AGENDA FOR REGULAR MEETING VILLAGE OF TINLEY PARK PLAN COMMISSION

October 2, 2025 – 7:00 P.M.
Council Chambers
Village Hall – 16250 S. Oak Park Avenue

**ITEM #1 PUBLIC HEARING – ACTION BEHAVIOR CENTERS – 8151 183rd STREET, SUITE B
– SPECIAL USE FOR SPECIAL NEEDS/THERAPY INSTITUTION**

PLAN COMMISSION STAFF REPORT

Site Plan of Proposed Outdoor Play Area

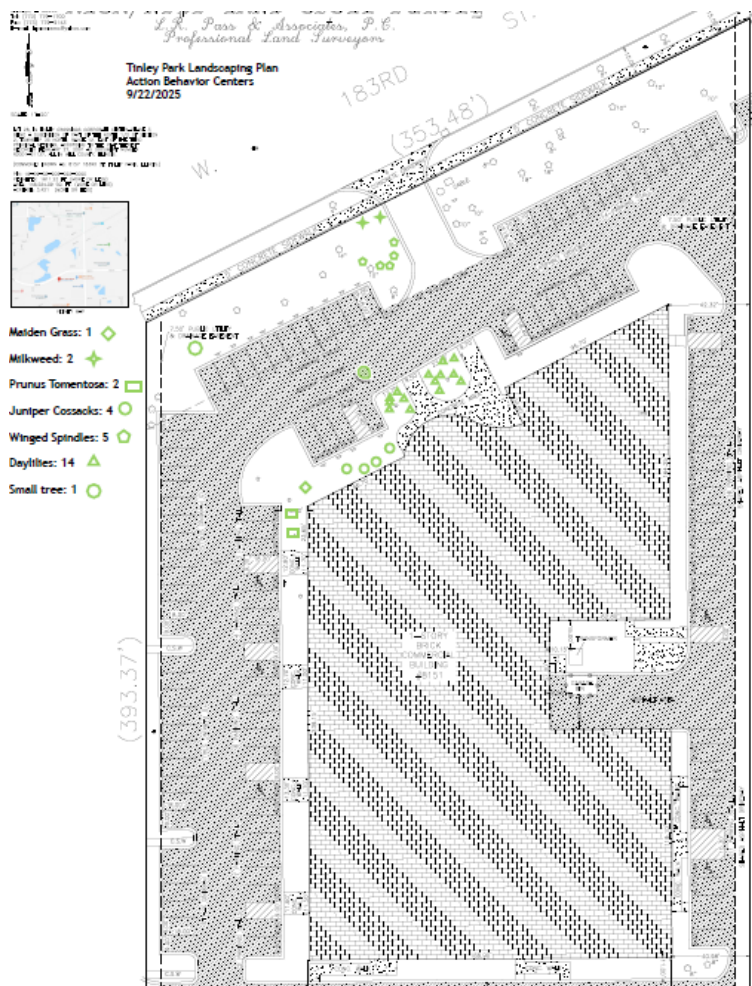
The location of the play area is directly in front of the tenant's space. It is internal to the site, away from the main curb cut access from 183rd Street. The play area directly abuts the existing concrete walkways to the tenant space, with the gate on the north side. The east side of the play area connects to the building, and the west side is a nominal distance from the existing curb. The head of existing parking stalls come up to the existing curb. Vehicles access the parking space via an internal drive aisle. Village Planning and Building staff note that adding wheel stops will provide additional protection to the outdoor area from vehicles parking in the vicinity. A **condition** is listed to this effect. The condition also notes a plan with material and location details is required for Village Planning and Building staff review and approval.

- 1. Wheel stops will be required to provide additional protection to the outdoor play area from vehicles parking in the vicinity. A plan with material and location details is required for Village Planning and Building staff review and approval.*
- 2. If landscaping plantings are not maintained and or do not survive the proposed relocations, then equal quantity and replacement is required. A new landscaping plan would then be required for Village Planning staff review and approval.*

EMERGENCY & HEAVY VEHICLE TURNING STUDY

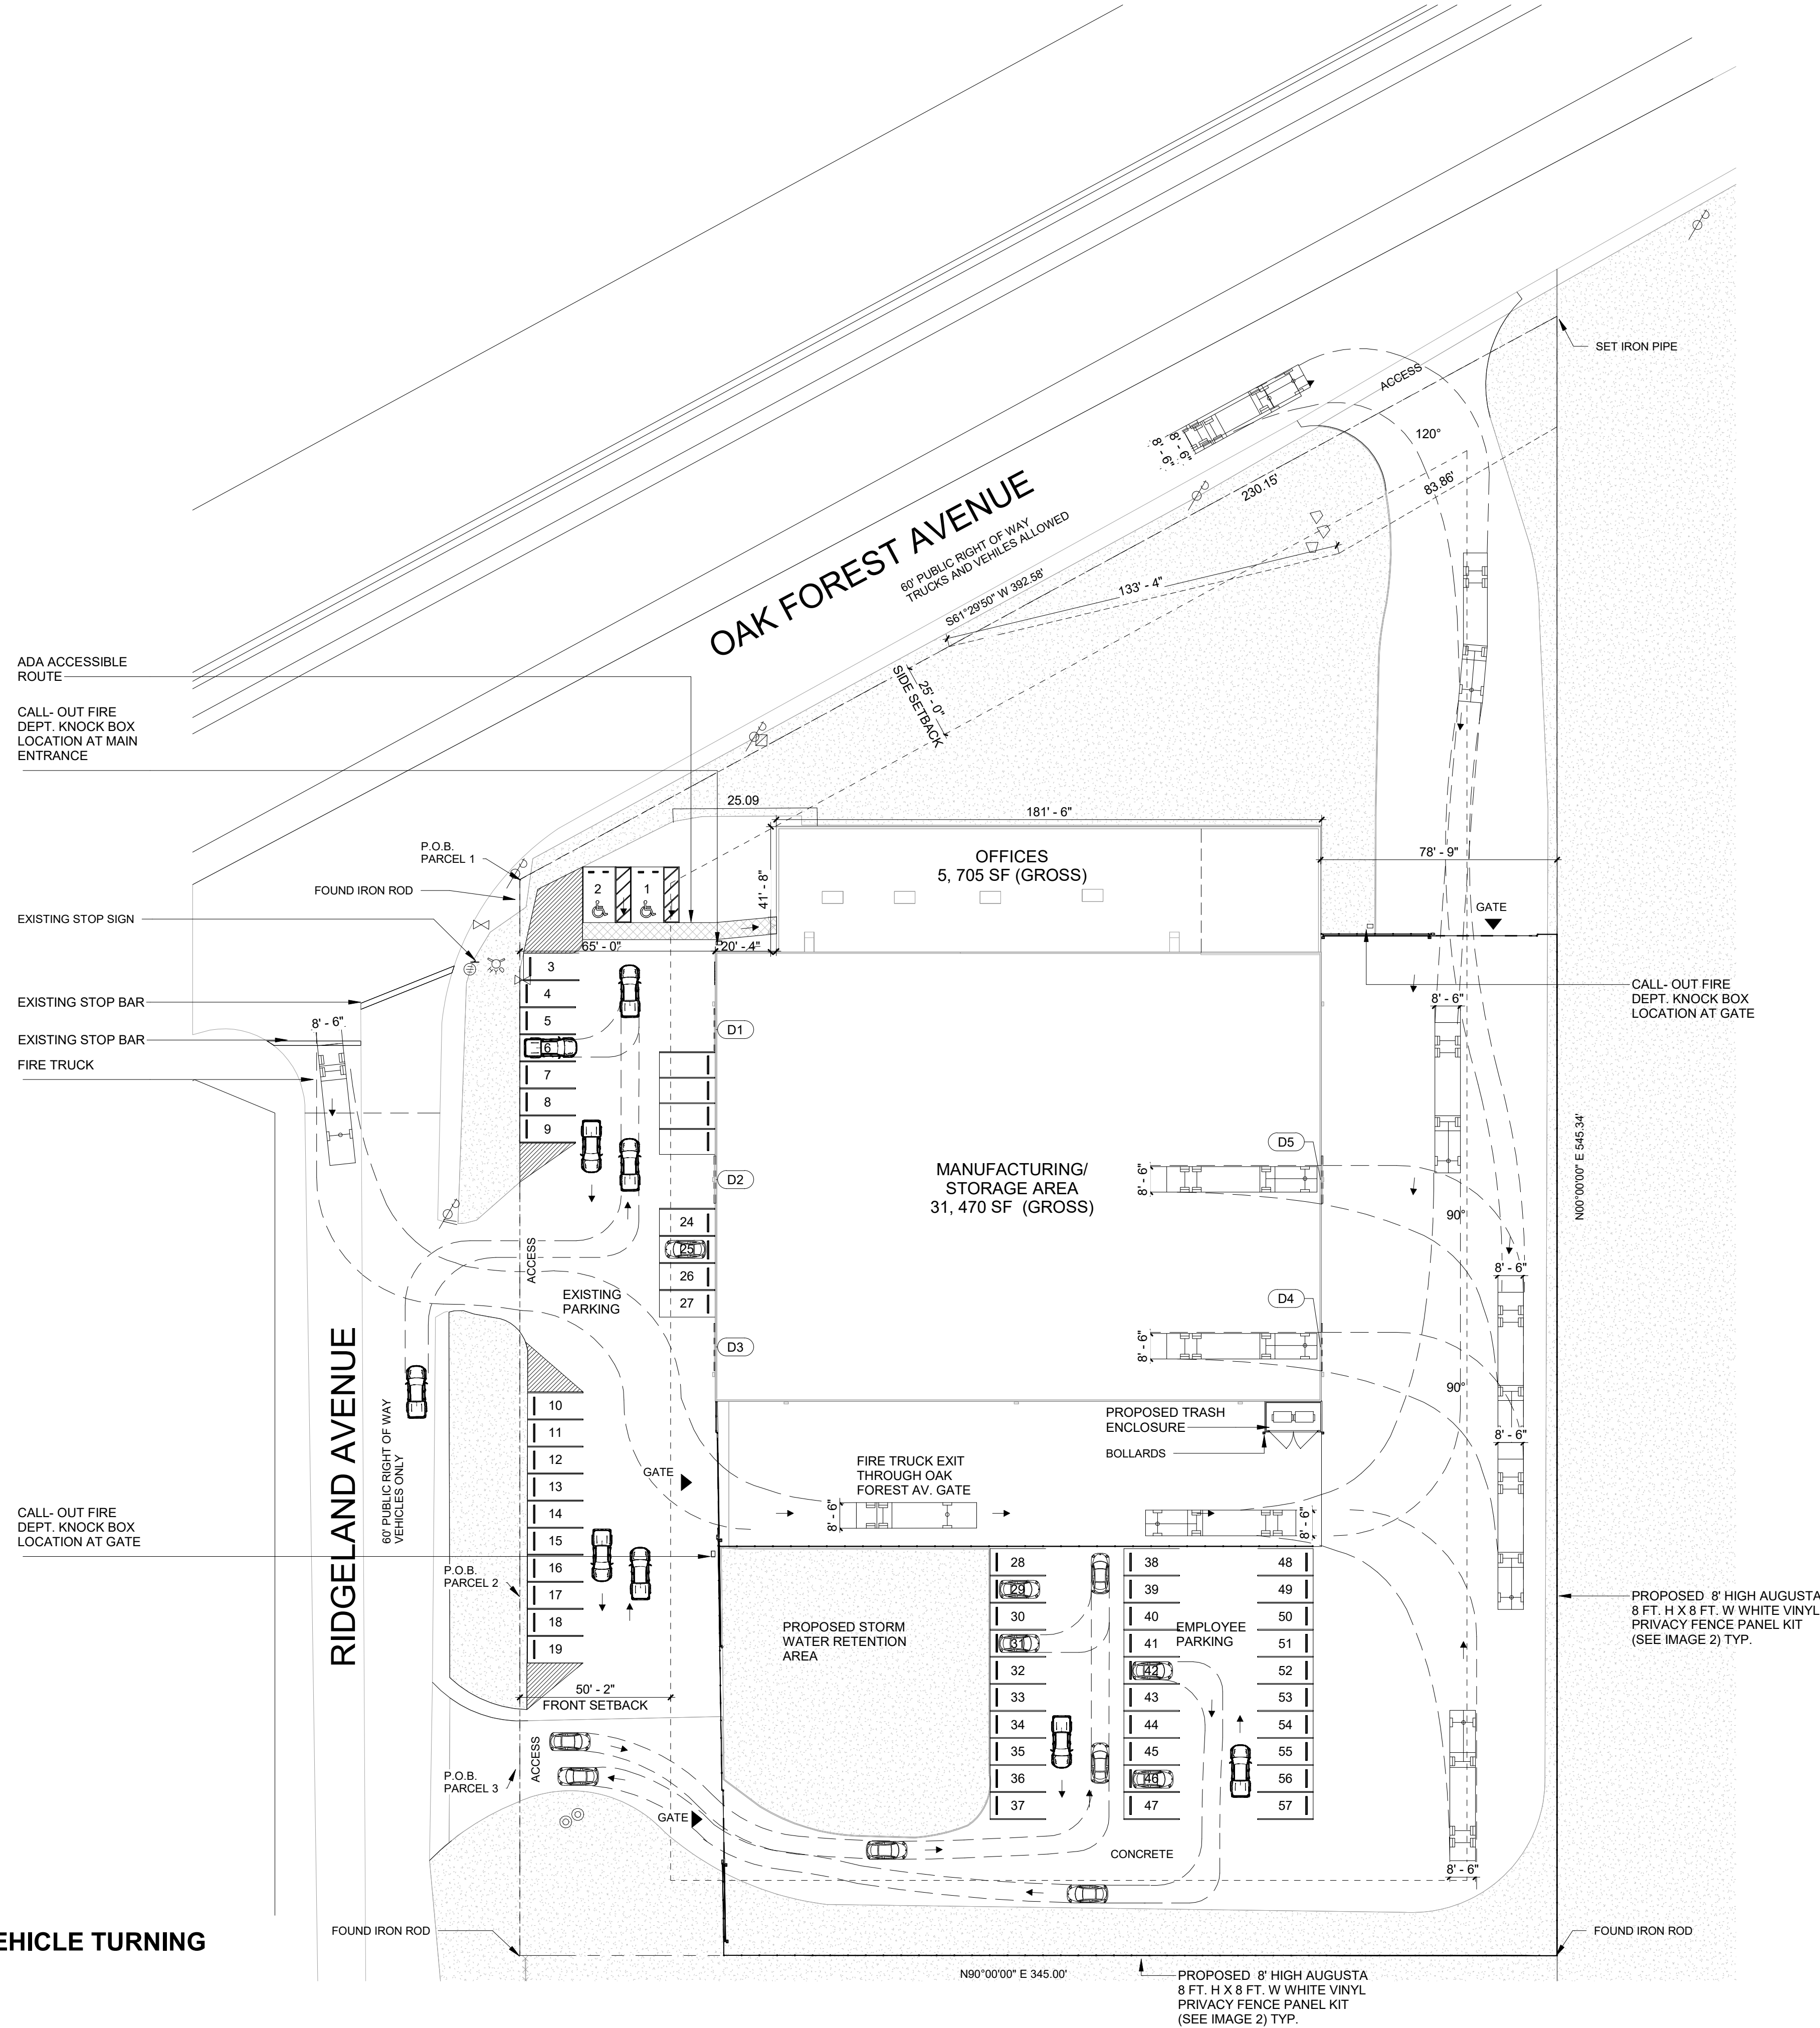
Along with the site plan (*above, right*), an emergency & heavy vehicle turning study (*above, left*) was provided. The Petitioner has verbally confirmed the trailers used to deliver out the finished product will utilize Oak Forest Avenue and the two east overhead doors, and that box trucks will utilize Ridgeland Avenue and the west overhead doors. Note that northerly western gate on the west side of the open storage area is intended for fire truck circulation.

The trash enclosure is located within the eastern part of the open storage area, at the southeast corner of the building, and appears accessible as the nearby trailer turning paths show the area is navigable.
